- 266 West Concord**
MEETING NOTES 8/17/13
- Present at meeting:
PK, Louise, John, Eric,
Tanya, Don, Robert, John M, Bryan
- GENERAL**
- 1) Tanya confirmed that the front (first to second floor) interior stair and the rear interior stair would be considered grandfathered for the headroom and egress needs to be checked and modified if necessary to meet existing code.

A-1.0

266 West Concord Street
Portland
14 January 2014

1
A1.0
Basement Existing Plan
SCALE: 1/4"=1'-0"

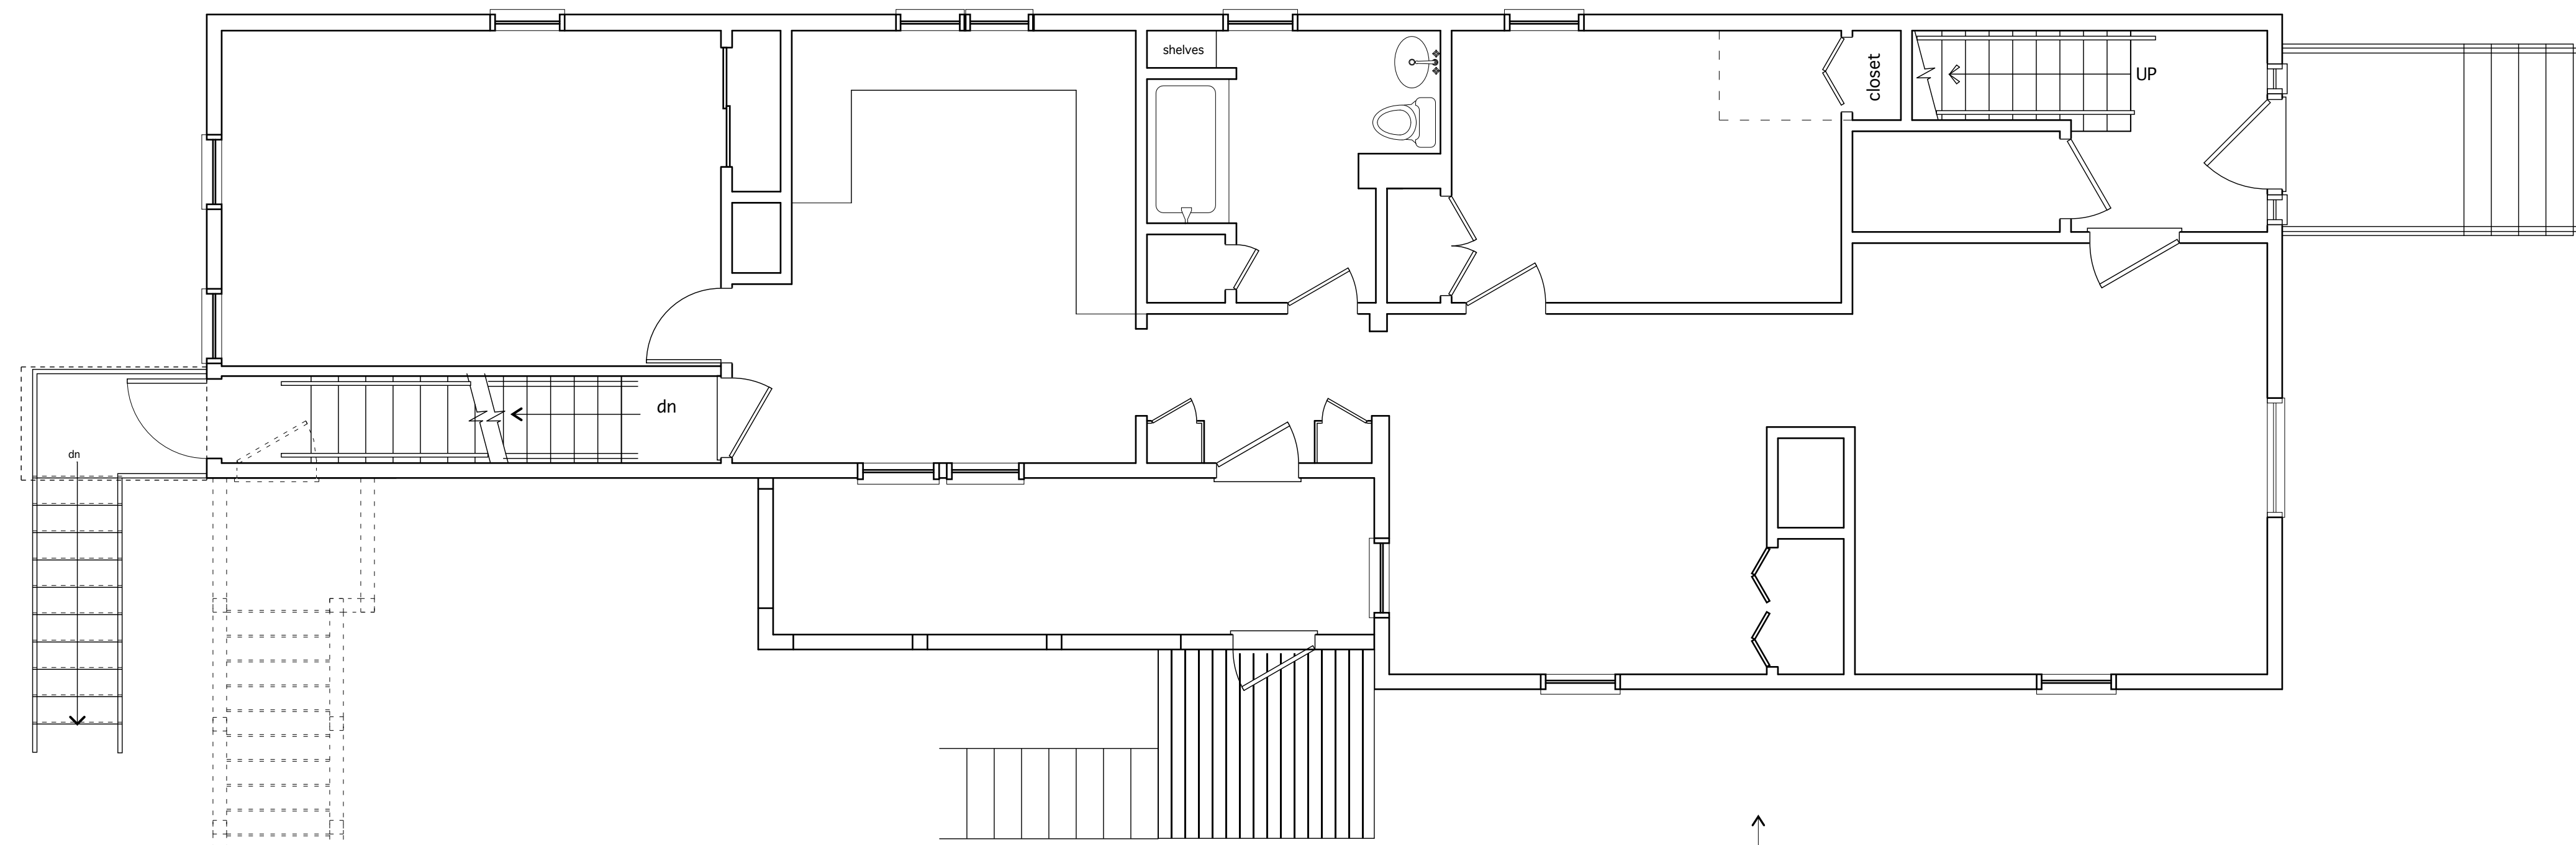
CODE ISSUES:
1. 1ST FLOOR FRAMING?
2. RATED CEILING.
3. DEHUMIDIFY.

- 14) All egress requests regarding stair guards can continue but all other renovation must wait for approved permit.
- Basement**
- 15) Laundry room is in basement as must be sprinklered.

- 16) John M. mentioned that brick piers looked questionable and should be replaced with masonry columns.
 - 17) A structural engineer will be needed to inspect the basement supports and to design framing sizes for all proposed beams.

- 18) New fireproof covering needs to be installed on unused flue pipe as cap on chimney.
 - 19) Egress railing and balustrade at rear stairs. Details to follow.

CODE COMPLIANT STAIR DETAILS

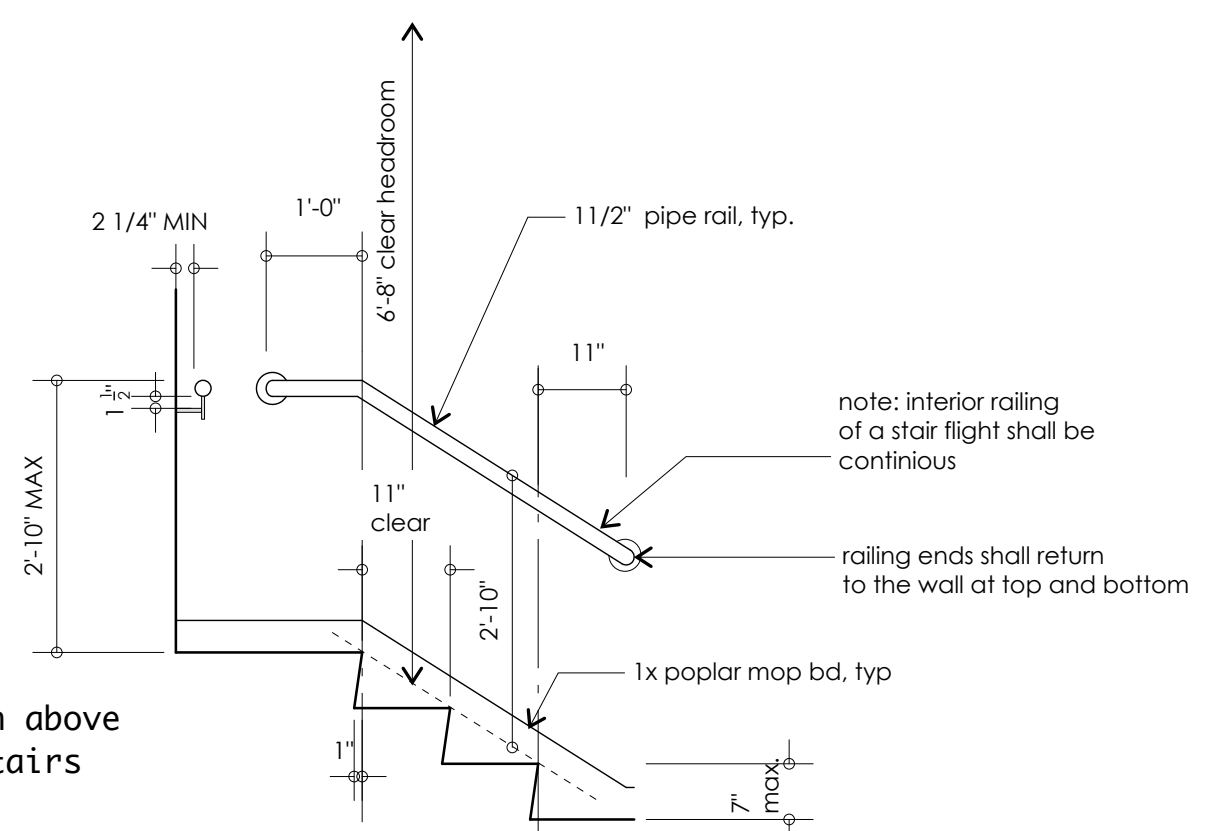
- 11) All electrical work on third floor needs to be to code compliant.
 - 12) All steel guard rail to be for rear stair. Details to follow.
 - 13) All stair stringer must have graspable handrail and return to wall. Details to follow.

- First Floor**
- 20) continuous graspable handrail to return to wall or post.
- Second Floor**
- 21) All new construction to wait for permit.
 - 22) New ceiling substrate for drywall.

- 23) New fire blocking at floor and ceiling levels.
- Third Floor**
- 24) All furniture at path of egress must be re-located.
 - 25) Apartment unit railing and balustrade must meet code (bottom to be extended). Most likely new stair will be built connecting headroom issue at stair in lieu of additional dormer.

CODE ISSUES:
1. RAILINGS
